ASSESSMENT REPORT

SCECGS Redlands School Senior Campus Concept Proposal and Stage 1 Redevelopment, Cremorne SSD 6454 MOD 1

Figure 3: Approved and proposed condenser location (Source: Applicant's Modification 1 EIS)

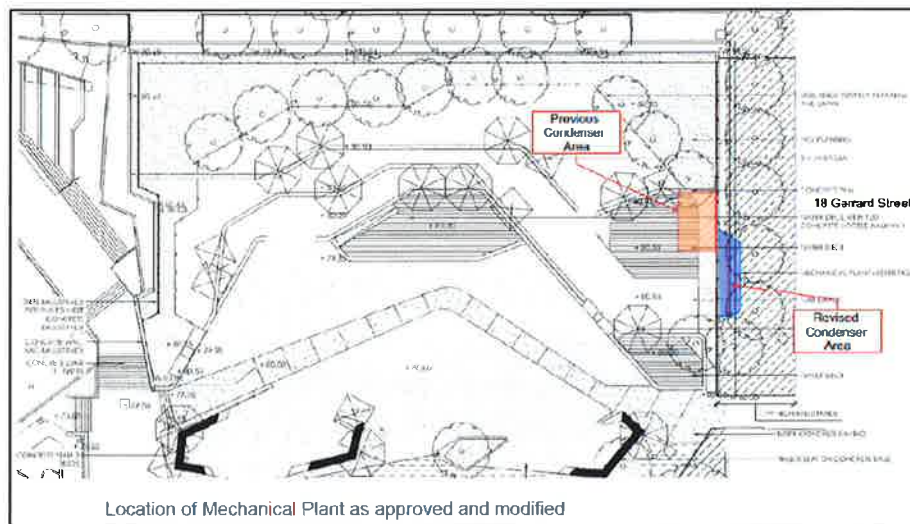
- Minor modifications to circulation routes, internal room configurations, and seating plans at the basement level (Interim Music Hub) to level 4.
- Minor modification to Stage 1 basement carpark layout including reduction from 63 to 61 spaces.
- Relocation of mechanical plant (condenser) to the eastern edge of the podium (Figure 3).

The location of the condenser unit as originally approved is shown in **Figure 3**. The application proposes to modify this location and move it closer to the eastern boundary shared with neighbouring residential units that front onto Gerrard Street. The Department originally imposed Condition B2. **Noise Attenuation Measures** which states the following:

The Applicant submitted as part of the modification application a letter from an acoustic specialist (Wilkinson Murray) outlining an acoustic review of the proposed location for the condenser unit. This assessment of the revised location for the condenser unit has shown that compliance can still be achieved as per the requirements of the original condition (F7 of the originally approved development)

and that the acoustic amenity of the residents to the east at 18 Gerrard Street would be protected. The review letter states that the proposed location is acceptable from an acoustic perspective.

- the condenser plant is in an area contained within the new carpark facility below ground level (and therefore, noise will be contained inside the carpark)
- the outlets will have 2D silencers installed on top of the unit
- the internal walls will be lined with acoustic absorption material
- the units that may operate in the evening are to be set on night mode to further reduce noise impacts generated.

The Department considers that despite the location of the condenser unit being shifted closer to the boundary, the new location is still governed by the requirements of the noise conditions as discussed earlier in Section 3.1 of this report. Furthermore, supporting documents provided show that the condenser unit can comply with the requirements of the condition. The neighbouring residential properties affected by the relocated condenser were notified of the application and no submissions were received in objection.

Therefore, it is considered that the proposed modification is acceptable as the Applicant is still required, and proposes to provide sufficient attenuation measures to prevent detrimental noise impacts, which are also not considered to be significantly different to what was originally approved.

Figure 4: Approved roof overhang in red (Source: Applicant's Modification 1 EIS)

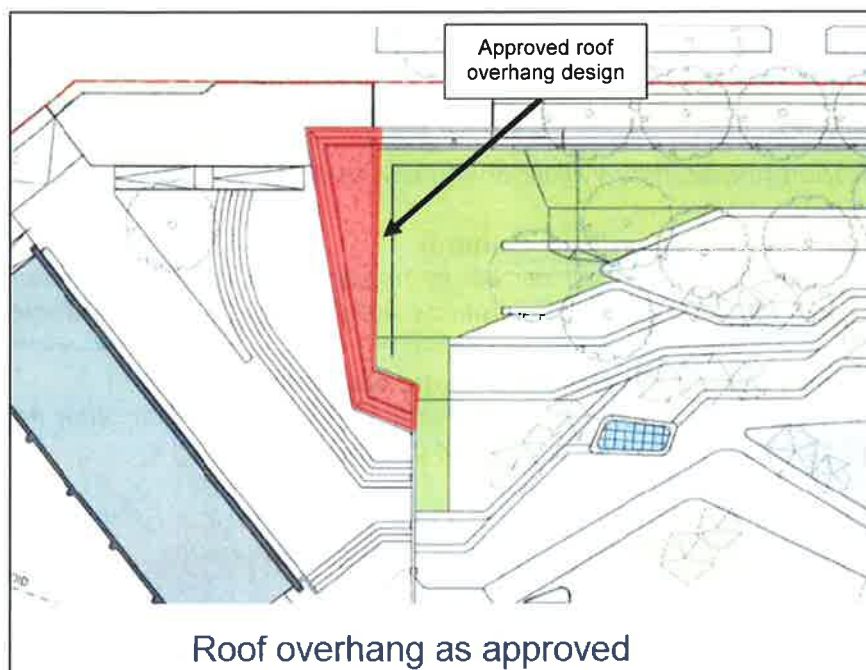
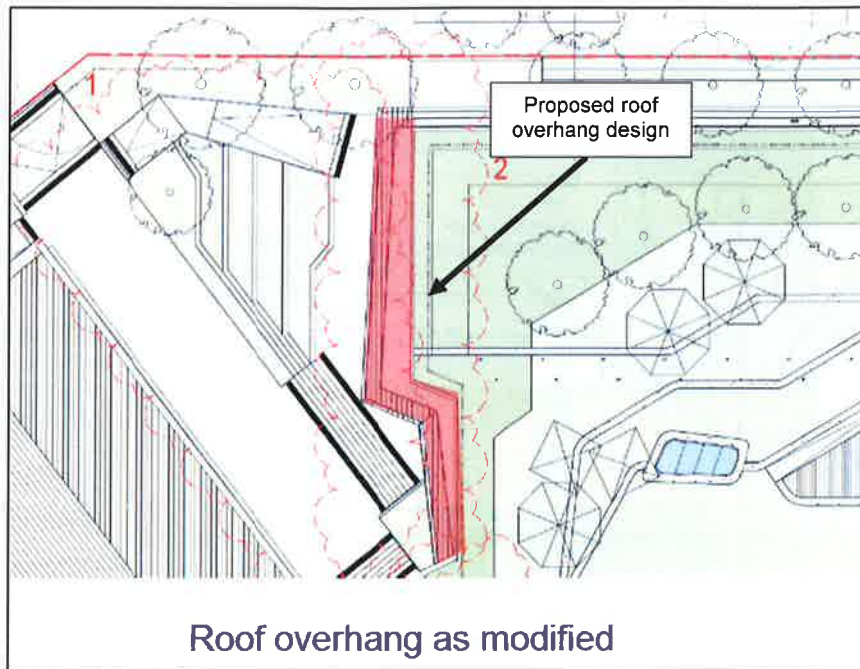
- Modification of the extent, profile and depth of the landscape podium roof overhang (Figures 4 and 5).

The proposed modification to the extent, depth and profile to the landscape podium roof overhang that is perpendicular to the Gerrard Street frontage of the building (as shown in **Figure 4**), is considered to be in keeping with the originally approved development. It is not considered that there will be additional detrimental impacts regarding solar access or amenity to the subject/neighbouring sites. Furthermore, the redesigned awning reduces the overall appearance of scale and bulk of the building towards the Gerrard Street frontage and provides greater cover as the building extends southwards into the site. Therefore, this alteration to the approved design is acceptable in this instance.

Figure 6: Foyer glazing to west elevation of interim music hub as approved (shown dashed in yellow, Source: Originally approved plans for SSD 6564)

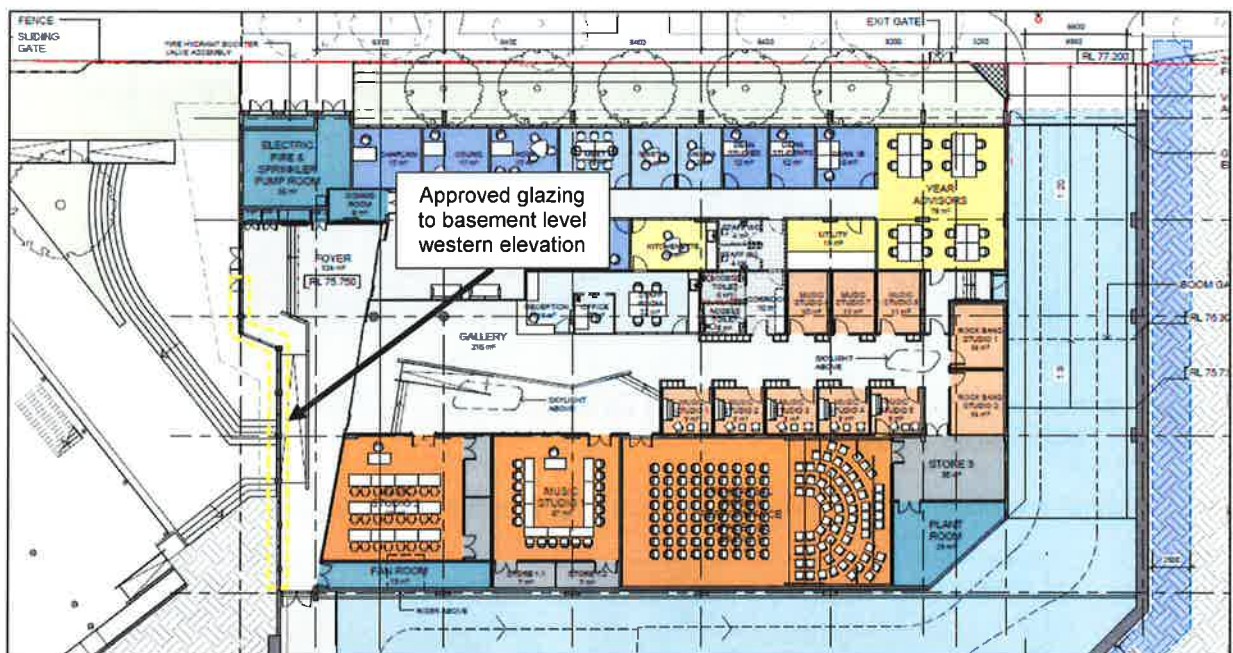
- Replacement of foyer glazing to the west elevation of the Interim Music Hub at the basement level with a solid wall (area shown dashed yellow in **Figures 6 and 7**).

It is considered that the proposed 100 mm increase in the basement level window sill height and the replacement of foyer glazing to a solid wall will not significantly alter the originally approved development. Furthermore, these modifications will not be readily visible from the public domain, increase the building height, scale or bulk and are not considered to have detrimental amenity impacts to neighbouring sites. Therefore, these modifications are considered to be acceptable.

Figure 9: Approved and modified entry forecourt area (shown dashed in yellow, Source: Applicant's Modification 1 EIS)

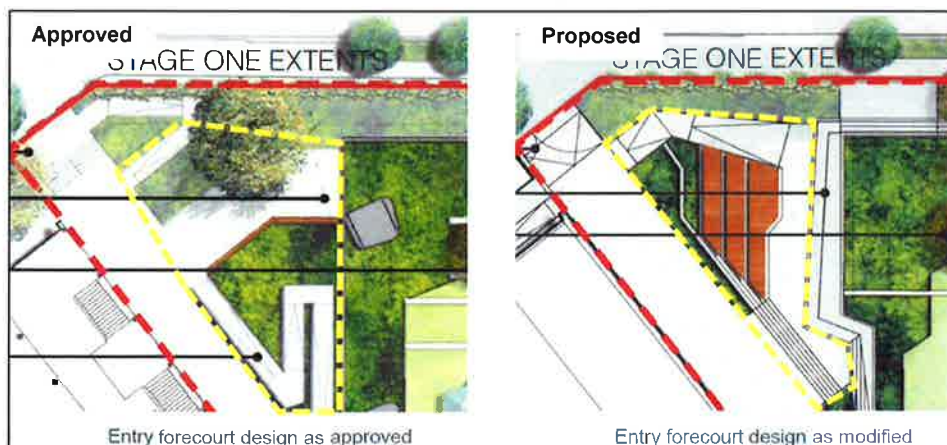
- Minor modification to the entry forecourt (ramp and stair configuration) (Figure 9).

The proposed modification to the forecourt area adjacent to the new pedestrian entry at Gerrard Street is similar to what was originally approved. The modified access ramps (leading from the forecourt) and pedestrian circulation paths are still considered to provide access within the site in a similar fashion to what was originally approved. Furthermore, this modification will not have any detrimental impacts towards the public domain.

Figure 10: Approved and modified podium landscape design (Source: Applicant's Modification 1 EIS)

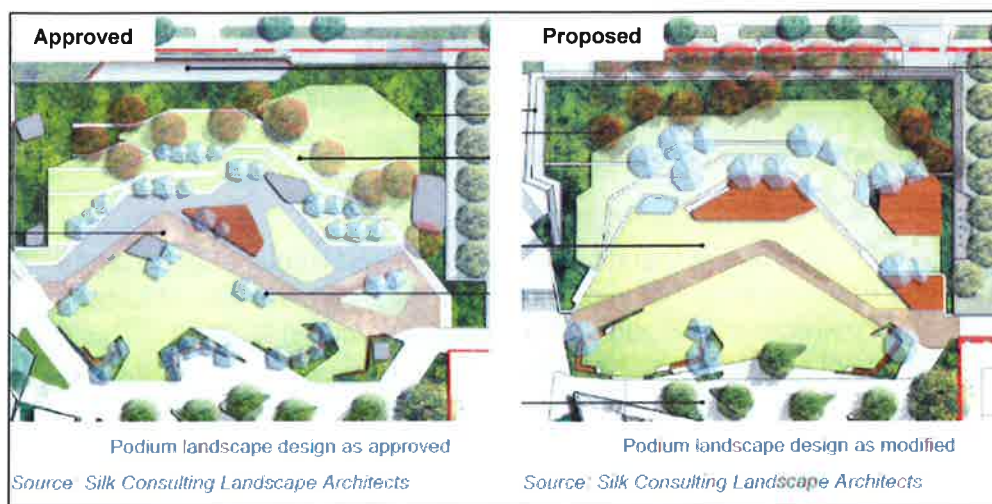
- Reconfiguration of podium and rooftop landscaped areas (**Figures 10 and 11**).

The podium and rooftop landscape modifications are related to changes in the design as to how the space is used, how pedestrian circulation is conducted and the materials types. The proposed modifications are in keeping with the overall character design of the originally approved development, do not alter the use and will not be readily visible from the public domain at street level.

Therefore, the proposed landscape modifications to the abovementioned locations are considered to be acceptable in this instance.
